Reply to Anonymous Referee #1

This manuscript presents an investigation of the spectral misalignment Effect (SMILE) on aerosol and cloud retrievals with a focus over land. A number of potentially important sources of biases are assessed. The paper is well suitable to the scope of AMT, in terms of the question proposed to address.

Figure 1. The relative error of single scattering albedo due to the non-corrected smile effect for different effective radii for ice (reddish colors) and water clouds (bluish colors). The example is given for the SWIR-1 band.

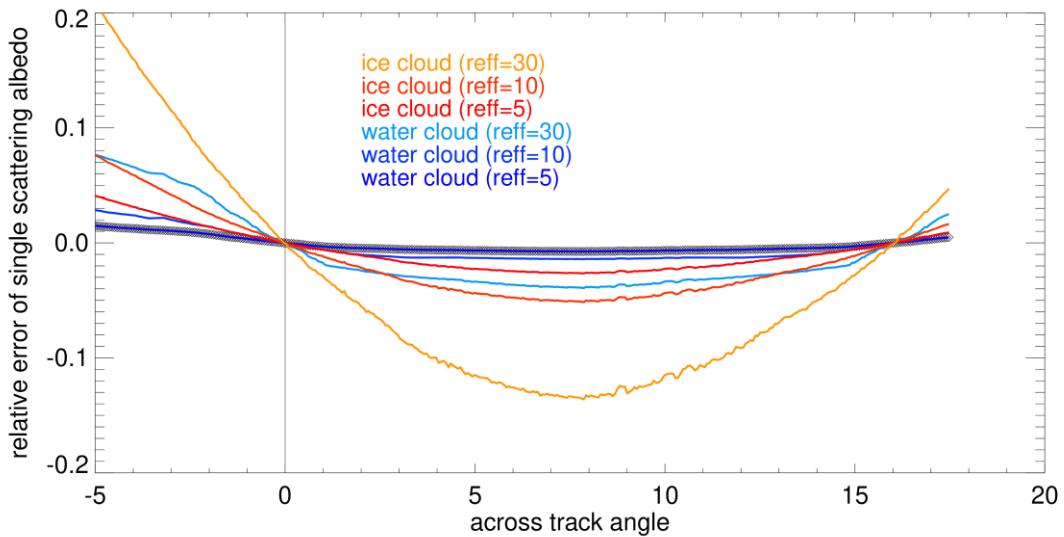
Figure 9: To what extent the results would differ from what you have, if you assumed COT to be 50, or liquid cloud effective radius being 10 or 20 microns?

If we assume cloud with COT=50, the VIS band errors will decrease as the surface will play no important role anymore. To understand the influence due to the cloud effective radius. We added the figure above here. The effective radius values are set to 5 μm , 10 μm and 30 μm with an optical thickness of 10. The surface is not varied. The water and ice absorption channels (SWIR-1) are primarily a function of cloud particle size; this is reflected in the results. The relative error for the single scattering albedo getting stronger for larger cloud particle (**Error! Reference source not found.**).

While an increase in COT with constant effective radius will result in a decreasing relative error, an increase in effective radius assuming a constant COT will result in an increase in relative TOA normalized radiance error in only the SWIR1 band.

Figure 2 International Satellite Cloud Climatology Project (ISCCP) cloud type definition in dependence on cloud optical thickness and cloud top pressure. Figure taken from:
<https://isccp.giss.nasa.gov/cloudtypes.html> (last access: 09 February 2024)

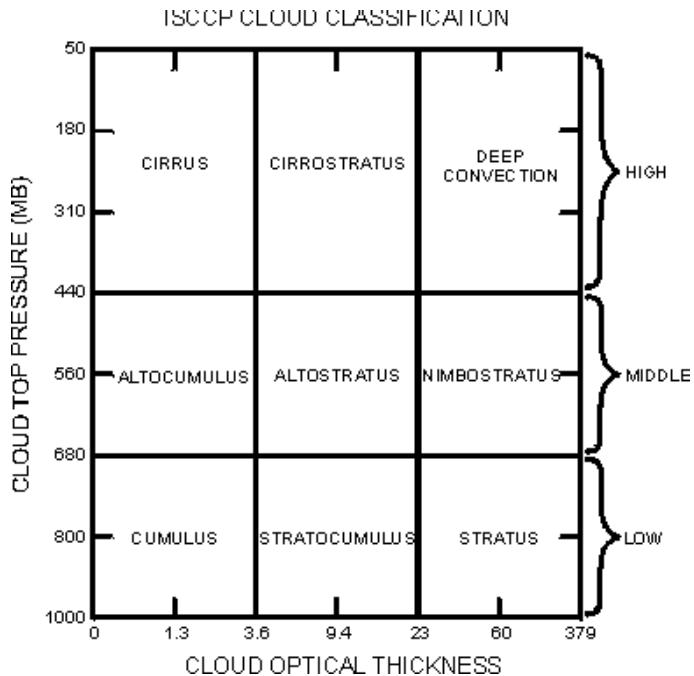
Line 205: optical thickness of 10 is low for stratocumulus. Please justify your choice.

Our target was to understand the possible error sources caused by the SMILE. One gets a good first approximation using a COT of 10. The value has been chosen for convenience

and is representative according to ISCCP (online: <https://isccp.giss.nasa.gov/cloudtypes.html> (last access: 09 February 2024)).
